North Coast Regional Water Quality Control Board

**Inspection Report for August 7, 2020 Consent Inspection,
Humboldt County Assessor's Parcel Number (APN) 214-142-012-000 (the
"Property")**

File: Cannabis Program Inspections, Humboldt County, August 7, 2020, California
Property Solutions Property, CIWQS Place ID 843377

Figure 1: Annotated map of property.

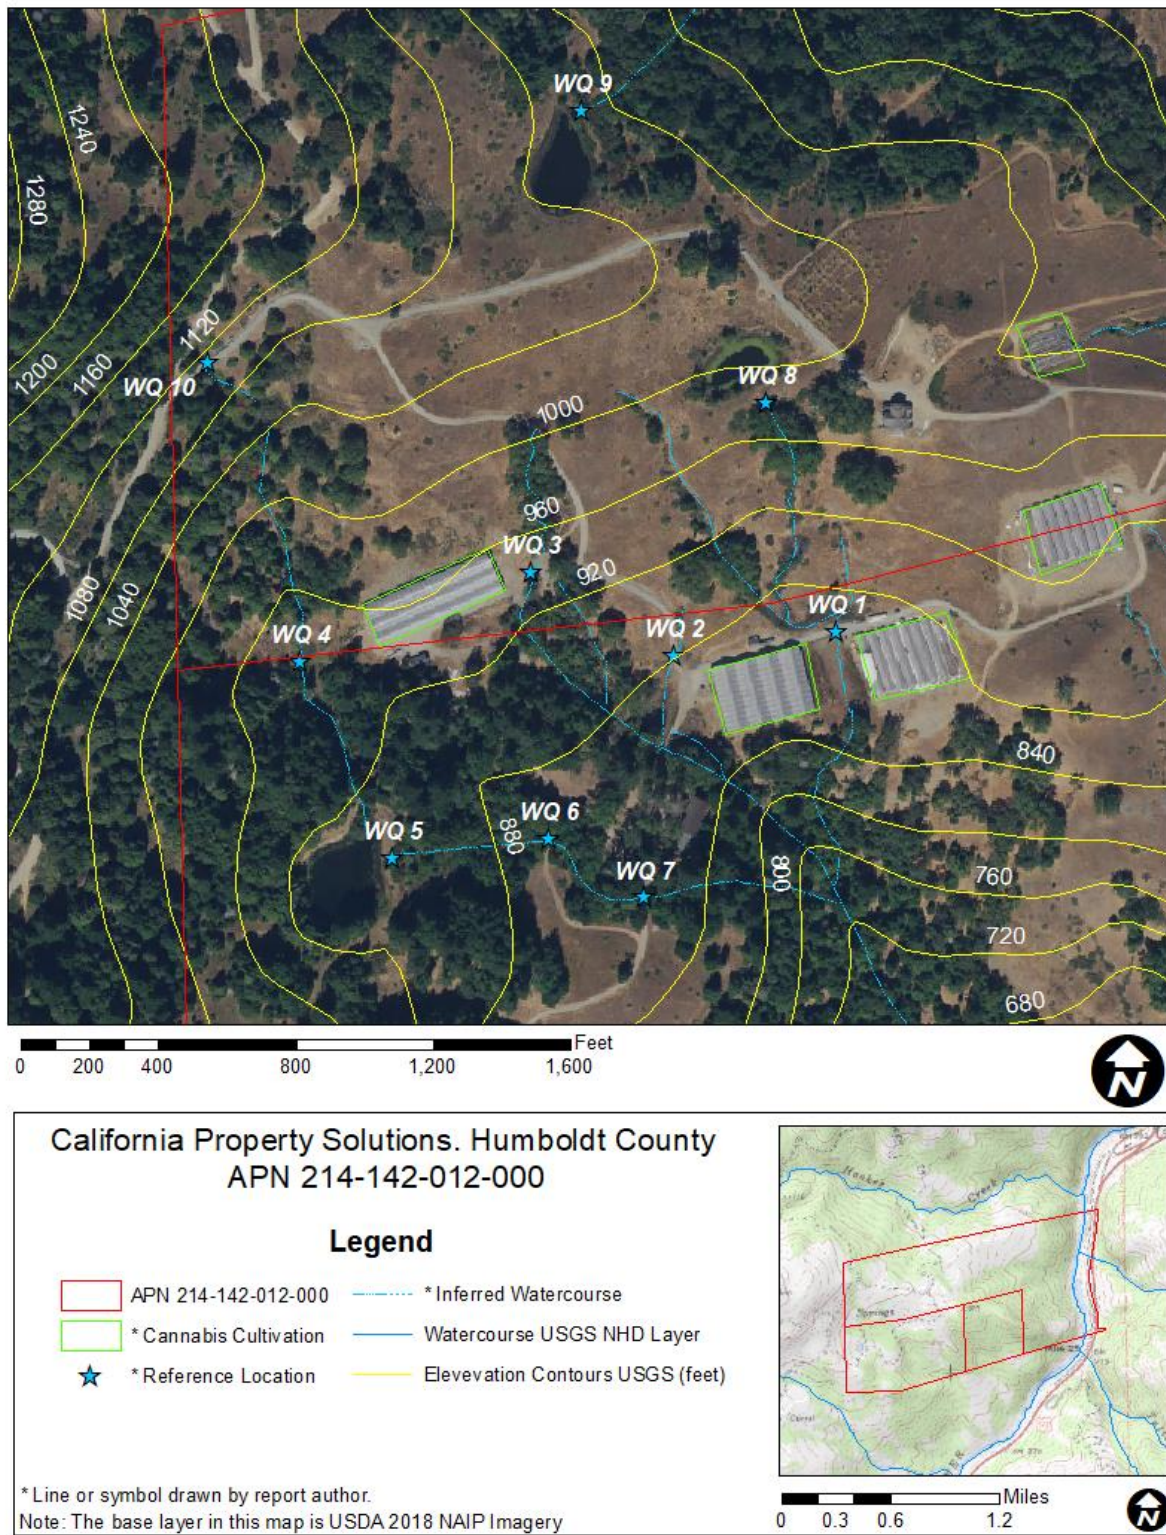
The Inspection Map, above, shows inspection points referenced and discussed below. Inspection participants met north of Redway at the east side of the bridge over the South Fork Eel River near Wood Ranch Road and agreed to inspect the Wetland Report study area at WQ 1 (Picture 1 and Picture 2) first. We entered the Property from the west, drove to WQ 1 and parked on the road crossing the feature from west to east. I observed that the wetland feature upslope and north of the road was intact. I observed that the road diverted all water from the wetland north to a single culvert in the middle of the study area, concentrating the flow. A watercourse, which is not visible in the pre-impact aerial imagery (Picture 2), had channelized from the culvert outlet to the southern extent of the cleared area where topography steepens, and the channel incises more deeply (Picture 3).

West of the westernmost greenhouse in the wetland study area at WQ 2, there is an area of bare earth where a north-south trending road intersects with the east-west trending road (Picture 1). Wetland features are still visible northeast of the road intersection and the SMP identifies a culvert carrying flow from the northeast to the western side of the intersection and two culverts returning the flow to the east side of the road further south (Picture 1). I recommended this area be included in the more detailed topographic survey area.

We walked west to WQ 3 where more than 100 feet of watercourse had been culverted. I walked from the culvert inlet to the culvert outlet and observed another watercourse parallel to the current culvert outlet channel that was closer to the culvert inlet and appeared to have been the likely continuation of the culverted watercourse before the culvert was installed. I also observed that the edges of the pad occupying the culverted watercourse had been covered with straw and demarcated to prevent traffic (Picture 4). I observed that the watercourse that the culvert is currently discharging into is deeply incised, and also receives several flexible plastic pipes that collect and transport the stormwater runoff from the roof of the nearby greenhouse. The inspection team discussed redirecting the culverted watercourse to the more proximal channel and minimizing the length of channel that is culverted for the intended use of the area as an access road to reach the greenhouse immediately to the west.

We continued west past the greenhouse and walked along an old berm impounding a watercourse at WQ 4. Mr. Twohig stated that the berm had been in place so long that wetland features had developed behind the berm. He proposed that rather than removing the berm immediately upstream from where the natural watercourse is, they could breach the berm farther south, so that the artificial wetland could remain intact and allow for excess stormflows to flow back north into the historical watercourse. I examined the berm and, although it seemed steep, I did not see any signs of instability such as tension cracks, sloughing or scouring from overflowing water. I was receptive to this proposal and stated that we would need to see a full plan.

We continued walking south to a larger reservoir at WQ 5. I walked to the downstream side of the impounding berm and observed water seeping from the ground over a broad area north of the reservoir outlet. I observed that the reservoir outlet was a rusted corrugated metal pipe with no water flowing through it. I observed a void, several feet high and deep, that had eroded into the berm structure below the outlet (Picture 5). TRC personnel proposed lowering the berm at the outlet location. Ms. White suggested the dischargers consider a plan that removed a longer portion of the berm than just immediately above the outlet.

We walked back to WQ 4 and then southeast to WQ 6 where I observed that the water diversion infrastructure, that I had observed in August 2018, had been removed from the watercourse. The SMP proposes decommissioning the culvert. We then proceeded east to WQ 7, where Mr. Twohig told us that the 36-inch diameter culvert was in good condition, however the expected 100-year flow event dictated a 54" culvert at the location. Mr. Twohig asked if there were site-specific considerations that would permit the smaller sized culvert to remain. I said we could consider site-specific conditions. I did not observe either local bed aggradation or degradation in the watercourse upstream or downstream from the culvert; however, I observed that the upstream watercourse averaged roughly 4 feet wide within a wider topographic trough and ascertained that the 36-inch culvert was likely undersized. Mr. Twohig proposed decreasing the road prism height above the culvert and adding a critical dip instead of

We returned to our vehicles at WQ 1 and drove east, then northwest, to a reservoir located at WQ 8. I observed some scour below the culvert outlet, but I did not observe any sloughing, cracks or evidence of water seeping through the reservoir berm. We then drove northwest to the reservoir at WQ 9. The impounding berm was heavily vegetated. I observed the corrugated metal pipe reservoir outlet extending several feet from the reservoir berm (Picture 6) and discharging into a scour pool downstream from the berm (Picture 7). I observed pooled water in the watercourse receiving the pond outflow.

We drove west towards the property exit and stopped at WQ 10. I looked at an aged culvert that drains an area north of the roadside to the hillslope to the south above a reservoir. The SMP includes a proposal to clean and maintain the ditch north of the road and clean out or replace the culvert. I looked at the culvert outlet and did not identify any signs of progressive scour, or flow outside of the culvert so I responded that the proposed treatment in the SMP seemed reasonable at this location.

1. Engage an appropriately qualified licensed professional to develop a detailed topographic survey of the wetland feature(s) at WQ 1 and WQ 2 to assist in identifying the extent of the wetlands that were present before the site was impacted in 2015. The survey should identify locations of non-impacted areas at the boundary of the earthwork as a reference of what the pre-impact topography was. The pre-impact topography should be compared to the current topography to show how much material was moved, where it was moved from, and where it was moved to.

2. Retain an appropriately qualified, licensed engineer to develop/review the plans described under recommendations 3 and 5 below.
3. Develop a plan to restore the wetland features at WQ 1 and WQ 2 to their extent and quality prior to the impacts discussed above, and a proposal for compensatory mitigation for the temporal impacts to these features.

4. Develop a plan to restore the watercourse at WQ 3 that avoids all permanent impacts that are practicable, minimizes the impacts that are not avoidable and mitigates for any remaining impacts.

5. Develop a plan to decommission the impoundments at WQ 4 and WQ 5. Ensure any remaining portions of the berms are stable and do not threaten to discharge earthen material to receiving waters.

6. Proceed with the scope of work proposed in the SMP for the culverts at WQ 6 and WQ 7.
7. Add to the SMP annual monitoring for the reservoirs at WQ 8 and WQ 9 that includes inspection for discernible cracks in any portion of the berm, freeboard height above the outlet structure, and any signs of underflow at the outflow exit or localized scour immediately downstream from the outlet.
